LOW VOLTAGE CIRCUIT BREAKER SALES & SERVICES

NO. YAMA438-A

Specification change of ACB

3. Exterior and design changes

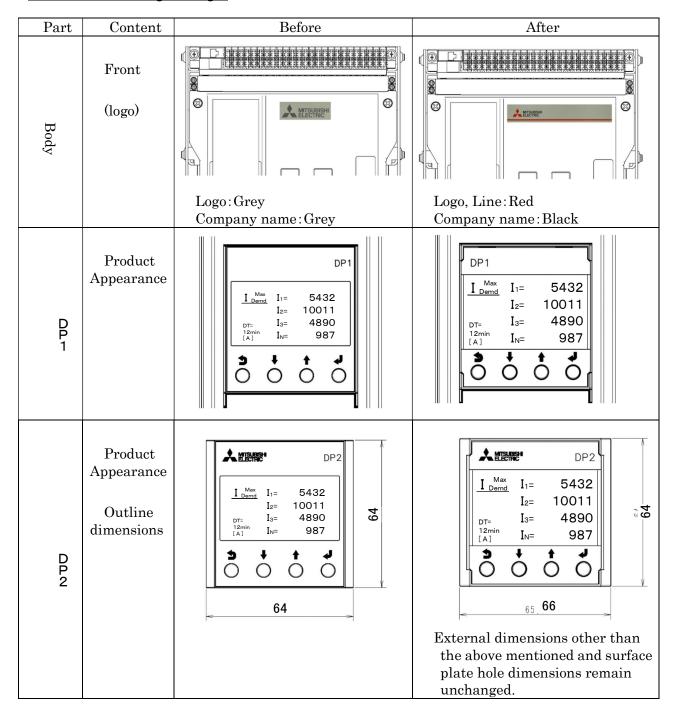
- (1) Design changes around the brand logo.
- (2) Additional new features to meet market needs.
- (3) Changed the shape of the LCD and display to improve visibility and availability of parts.
